Subject: Water Right Application 61-12090 (in the name of Nevid LLC)

MEMORANDUM

RE: *Response to IDWR memos regarding aquifer recharge along I-84 corridor from Boise to Mountain Home*

Figure 1. Ground water surface elevation contours (50-ft).

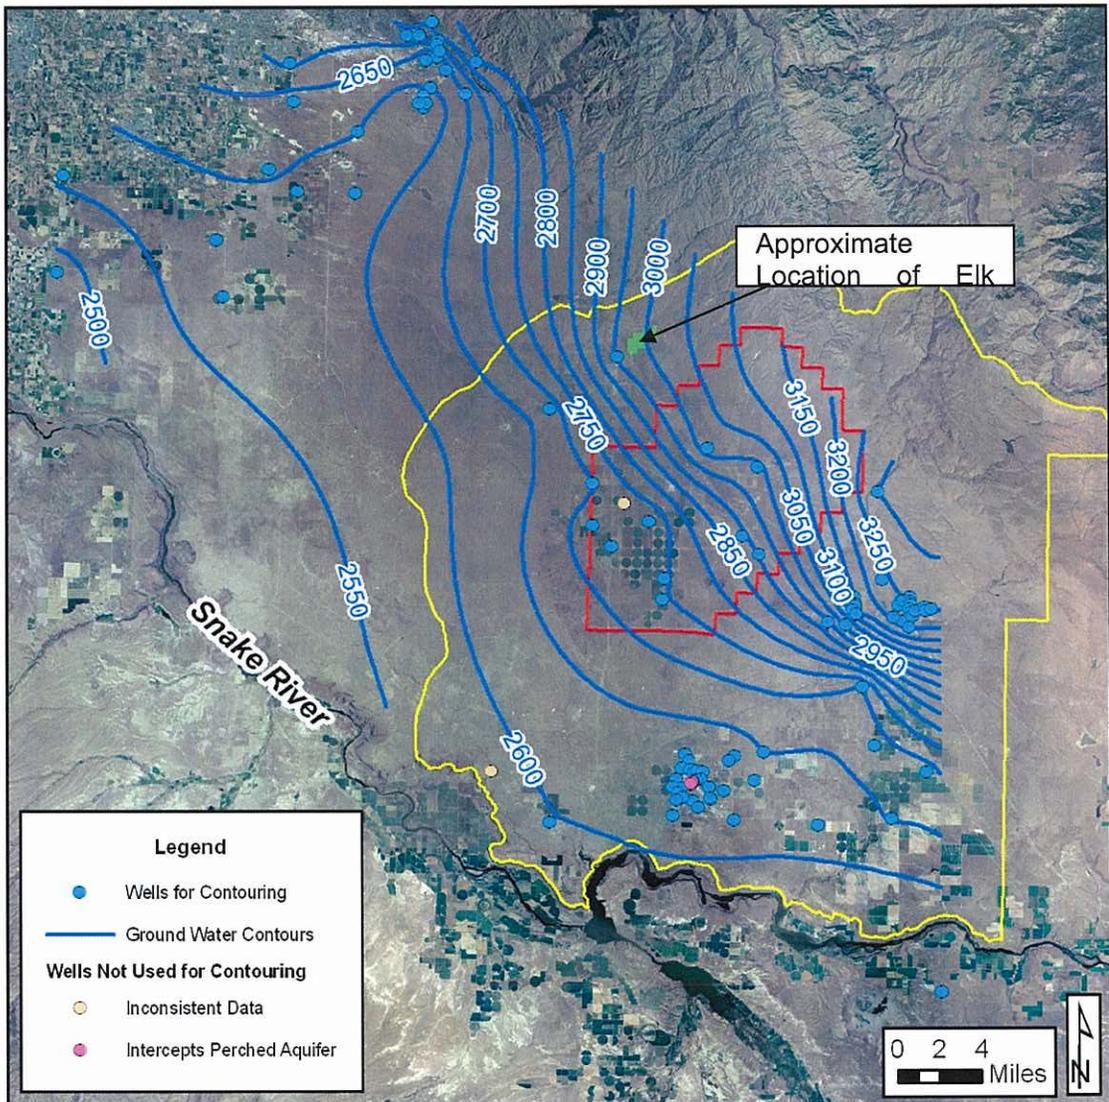
- a. Ground water in the vicinity of the Elk Creek Village flows in a southwesterly direction perpendicular to the water level contours shown in Figure 1. A cone of depression emanating from the Cinder Cone CGWA (coarsely illustrated with the 50-foot contours shown in Figure 1) does not intercept flow from the Elk Creek Village area. Furthermore, a water level change map in Figure 1 of the Tesch and Vincent memo does not show declines reaching the Elk Creek Village area.

Figure 2. Surficial geology showing inferred faulting parallel to the Danskin Mountain front (Bond and Wood, 1978).

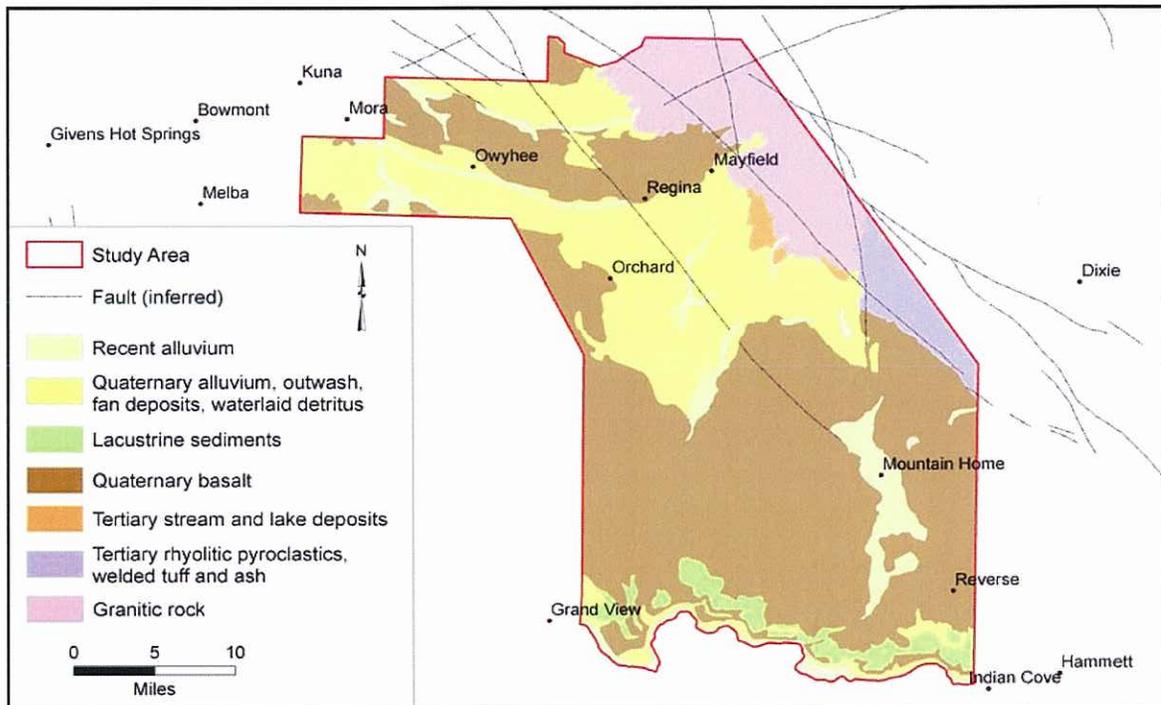
- b. It is noteworthy that pumping in the Cinder Cone CGWA has not reached the Elk Creek Village area in 40 years of pumping. The extension of a cone of depression from the Cinder Cone area may be, in part, precluded from extending to the Elk Creek Canyon area by leaky hydraulic boundaries associated with faulting parallel to the Danskin Mountain Front (Figure 2). Seismic geophysics proposed for the summer of 2009 may help identify faulting in this area.

Figure 3. Theoretical drawdown after a period of one year.

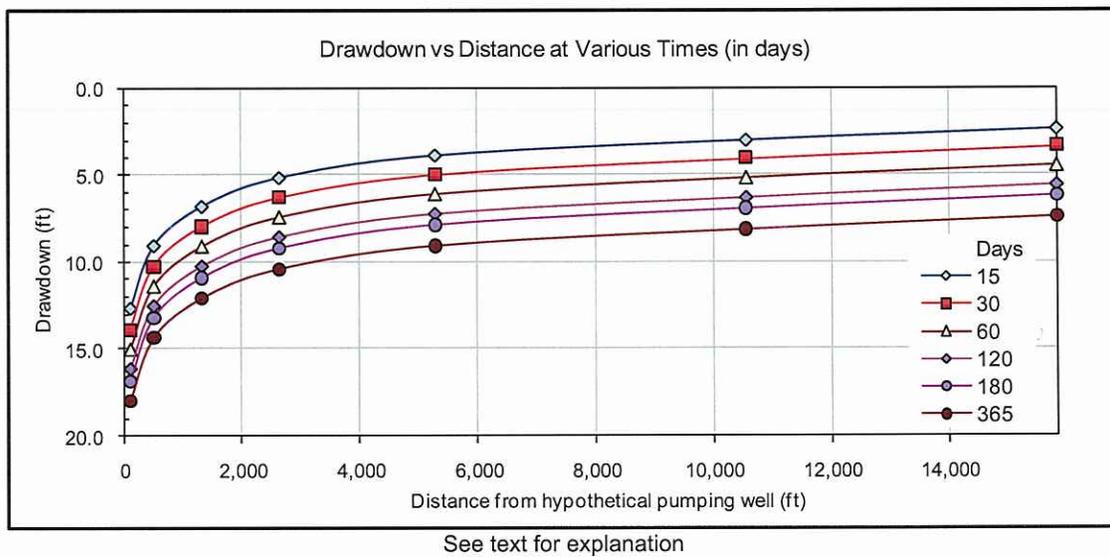
- ii. For comparison purposes, a Theis analysis (Theis, 1935) was performed to determine the potential capture zone for pumping under application 61-12090. Using the same transmissivity used in the WhAEM model by IDWR (25,000 gpd/ft), an assumed

storativity of 0.005, and an average withdrawal rate of 0.8 cfs (which provides for an annual withdrawal of 577 AF under the Elk Creek Village application), a water level decline of up to about 8 feet is possible at a distance of 2 miles after 1 year³. (Figure 3). This shows the possible extent of a capture zone. Note, however, that any recharge to the aquifer during the year of withdrawal would reduce (or eliminate) this long-term drawdown predicted using the Theis solution. The Theis solution, like the WhAEM model, is a 2-dimensional solution that does not account for boundary effects, vertical ground water flow, or hydraulic discontinuities.

Figure 4. Soils in the Elk Creek Village area.

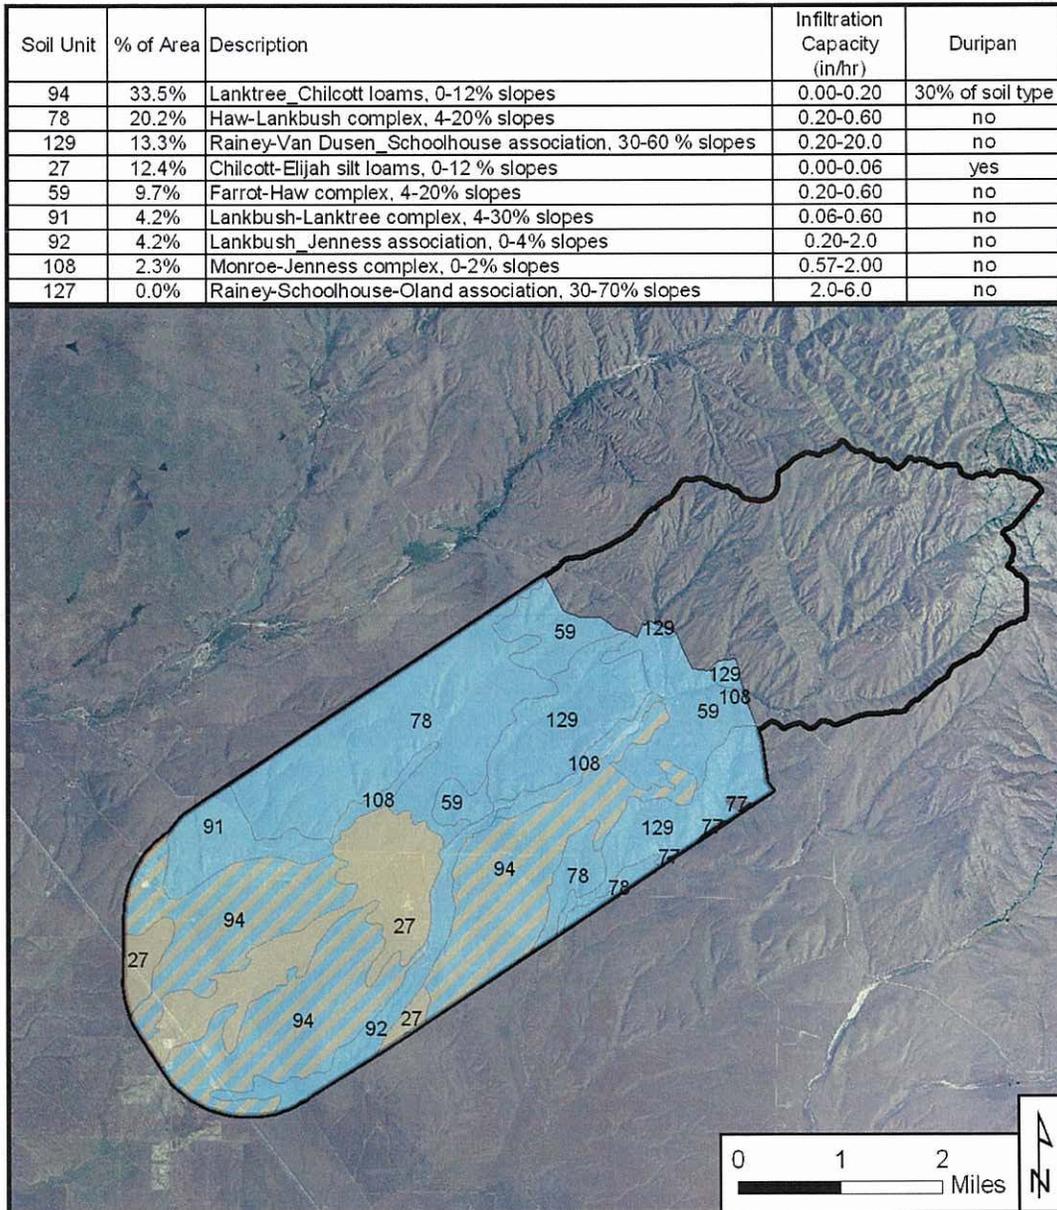
- i. Soils with duripan layers cover about 22 percent of the estimated sedimentary infiltration area for the Elk Creek Village.
 - ii. Soil unit 27 (Figure 4), which has low-permeability (i.e., duripan) characteristics, covers about 12.4 percent of the sedimentary portion of the Elk Creek Village infiltration area.

- iii. Thirty percent of Unit 94, which covers 33.5 percent of the sedimentary infiltration area, has duripan low-permeability characteristics.
 - d. Most of the soil (78 percent) in the sedimentary portion of the Elk Creek Village capture area consists of soils without duripan. We believe that higher permeability soil near the basin margin in this area justifies the 5 percent infiltration rate assumed in the Mayfield Townsite and Elk Creek Village studies.

Figure 5. Assumed capture area for areal infiltration and contributing watershed areas for surface channel seepage. Surficial geology from Bond and Wood, 1978.

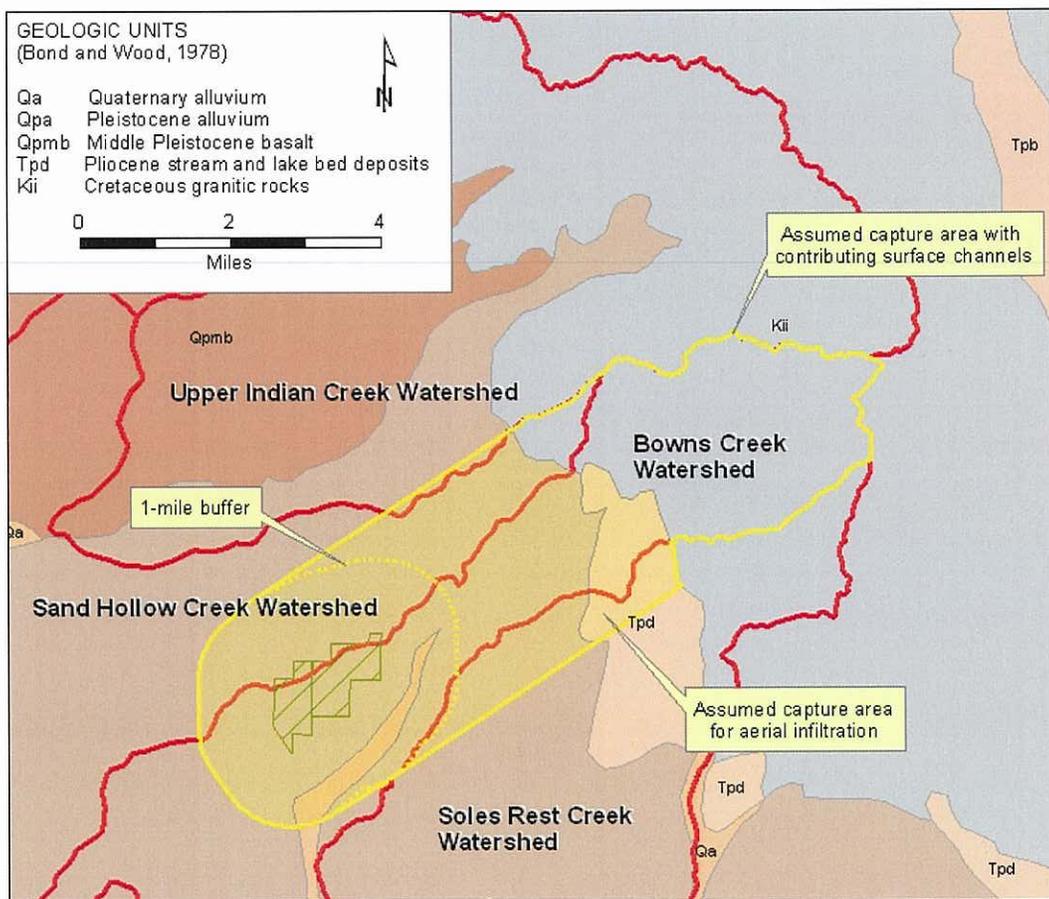
Four watershed areas define surface water flow in and upgradient of the property, shown in Figure 5. However, these surface water drainages do not necessarily define subsurface flow divides. Aquifers in the area extend beyond, and can be influenced by, recharge and discharge from areas outside of these watershed areas. For this analysis it was assumed that the capture area for aquifers in the project area and the area of well withdrawals near the Elk Creek Village property is the area upgradient and within approximately 1 mile of the Elk Creek Village property but limited by contacts with granitic rocks (Figure 5). The assumed capture area for areal infiltration is approximately 12,000 acres.

primarily sedimentary areas. These upper watershed areas include approximately 5,400 additional acres (Figure 5).

1. The recharge capture zone was decreased from a 2-mile radius around the Elk Creek Village property to a 1-mile radius.
2. Wintertime evapotranspiration was added to the annual evapotranspiration.
3. Evapotranspiration estimates were made using data from ET Idaho.

Figure 7. ET Idaho weather stations.

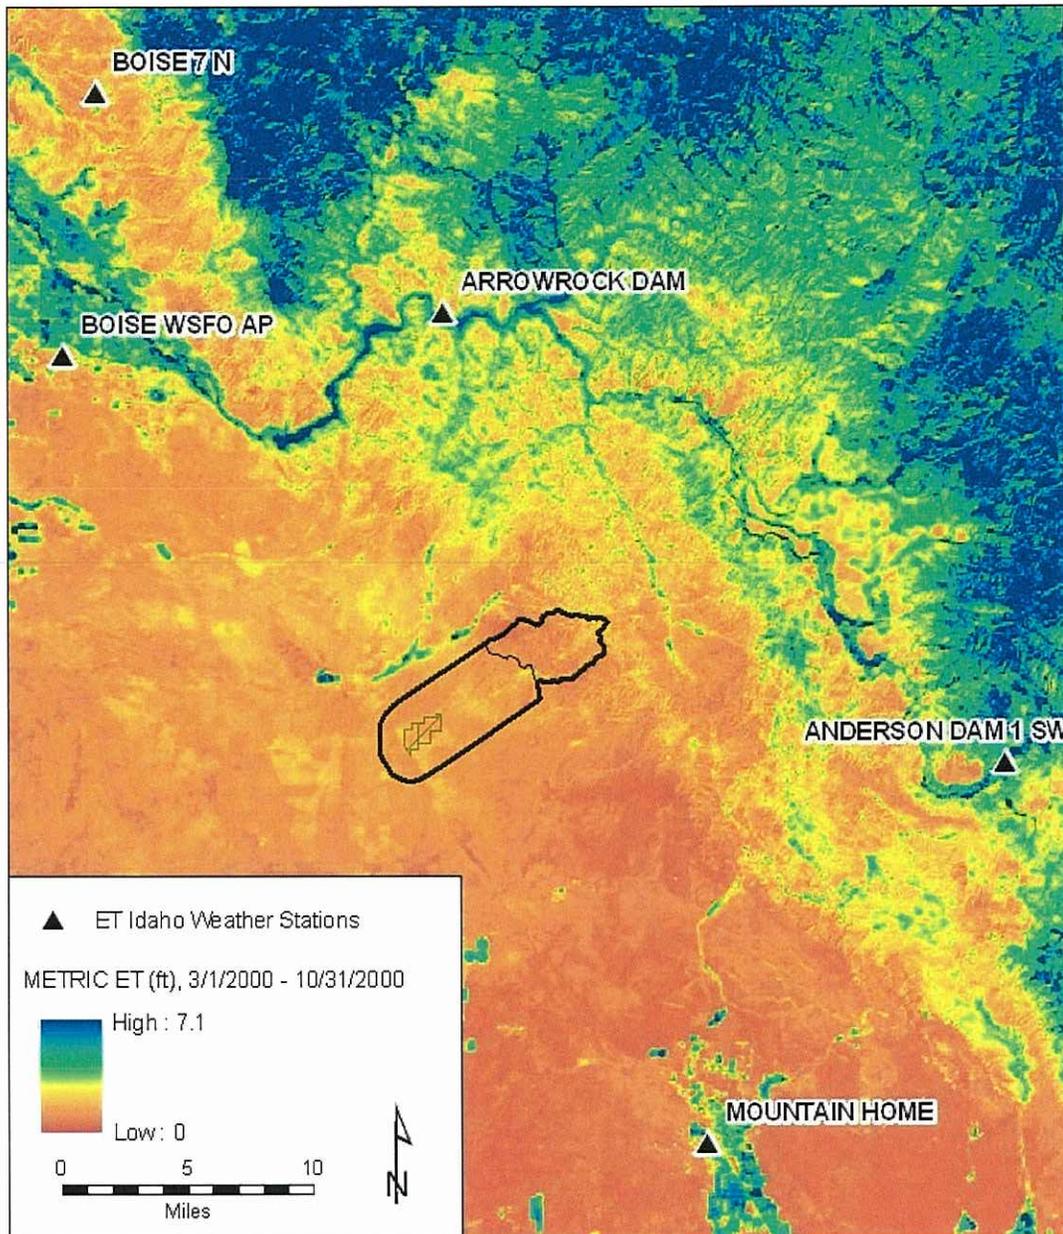
approximately 9.0 inches (or approximately 0.75 AF/acre). From ET Idaho, the average evapotranspiration during the wintertime months (November through February) for sage brush and rangeland at five area weather stations (Figure 7) is similar (ranging from 1.85 to 2.00 inches). An assumed average value of 1.93 inches during the wintertime months yielded an additional 2,780 AF of evapotranspiration for the Elk Creek Village area, resulting in a total estimated evapotranspiration of approximately 15,900 acre feet.

The use of Anderson Dam weather station data may be conservative in the sense that it could yield a higher estimate of evapotranspiration than actually exists. This is because METRIC evapotranspiration data (Figure 7) show lower evapotranspiration rates in the Elk Creek Village area than near the Arrowrock Dam and Anderson Dam locations. While METRIC data may have inherent error in non-agricultural areas (resulting from lack of calibration), the relative spatial differences are likely to be relatively accurate⁹.
